**BHP Canada Exploration Drilling
Project EL 1157 and 1158
Information Requirement Responses**

Prepared for:
BHP Petroleum (New Ventures) Corporation
235 Water St.
Suite 701
A1C 1B6

Prepared by:
Stantec Consulting Ltd.
141 Kelsey Drive
St. John's, NL A1B 0L2
Tel: (709) 576-1458
Fax: (709) 576-2126

Report

Figure 1 Revised EIS Figure 6-17: Spotted Wolffish Distribution and Abundance Compiled from Canadian RV Trawl Survey Data (2012-2017) with Designated Critical Habitat

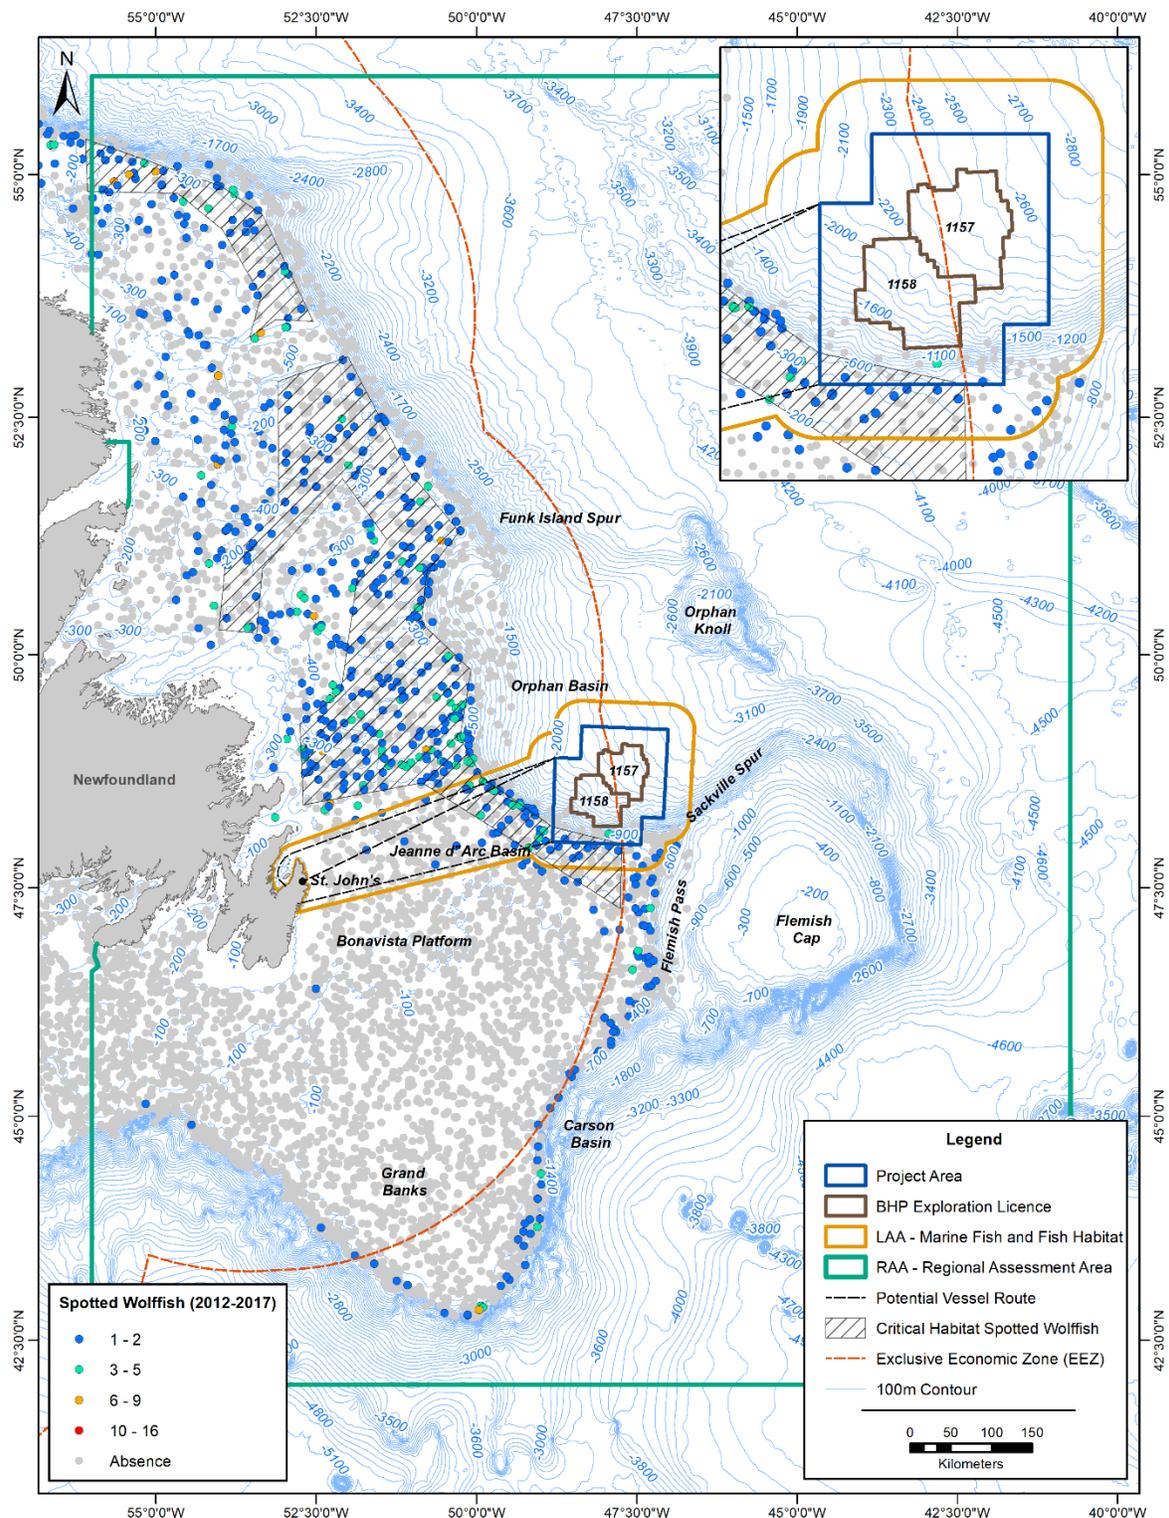
Figure 11-1 of the EIS identifies proposed critical habitat for Northern and Spotted Wolffish.

Confirm that figures in the EIS depicting wolffish critical habitat (e.g., Figures 6-17; 6-18; 11-1) remain accurate given the recently finalized boundaries. Similarly, confirm that the information on the overlap of wolffish critical habitat with the project area and LAA, as well as distances from spatial boundaries (e.g., ELs, project area, LAA, PSV routes) remain accurate. Update this information and these figures, as required.

There is no change to spotted wolffish critical habitat between the proposed and finalized boundaries as depicted on EIS Figures 6-17, 6-19, and 11-1. Finalized northern wolffish critical habitat (where it overlaps the spotted wolffish critical habitat) was extended to the Exclusive Economic Zone (EEZ). EIS Figures 6-17 and 6-18 depict the finalized Critical Habitat. Figure 11-1 depicts the finalized Critical Habitat, although it does indicate “proposed” Critical Habitat in the legend. Revised EIS Figures 6-17, 6-18, and 11-1 are provided as Figures 1 to 3, respectively.
